DA OBJECTION

3 JULY 2024

RE: DA 2024/0774
6 MITCHELL ROAD, PALM BEACH
WRITTEN SUBMISSION: LETTER OF OBJECTION
SUBMISSION: TULLOCH

Photograph 8: Overhang/undercutting within the site.

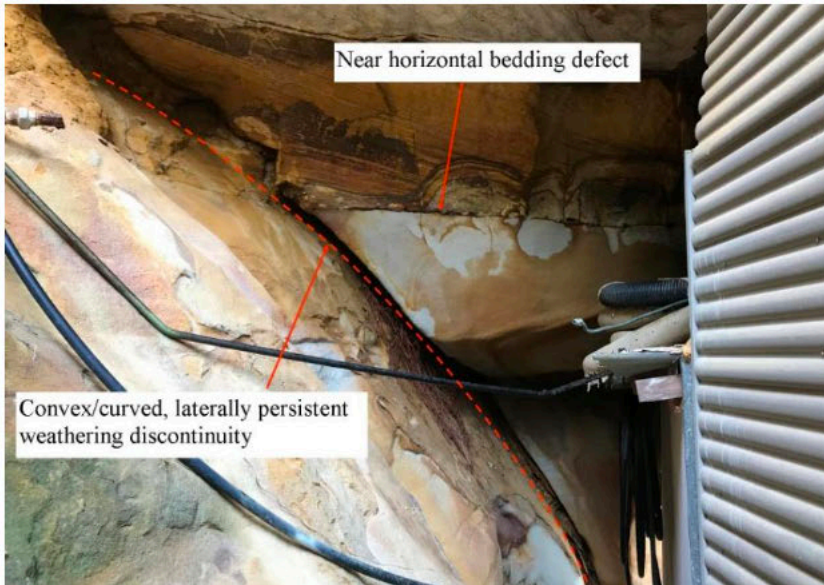
The Crozier Report is very well constructed, however I am concerned on the risks of building a 9.4m high Turning Bay over zones that are considered 'high risk' by Crozier. The proposed Turning Bay is positioned directly over the unstable 'Cliff Overhang' as seen on Crozier Figure 1 [page 34 of 60] – how the 'high risk' overhanging cliff is protected during construction of a 9.4m high Turning Bay above, with substantial loads to be transferred back into the bedrock, is uncertain. This may require a massive cantilevered structure of the highly loaded Turning Bay to avoid the unstable ground, but again no detail is provided by the architectural drawings or engineering drawings. This is required, as the design outcome may be significantly different to that drawn. I provide extracts from the Crozier Report including extracts of some photographs, as clearly the architectural and engineering drawings have avoided the issue:

- *Several significant overhangs and potential destabilising defects were identified in the mapping*
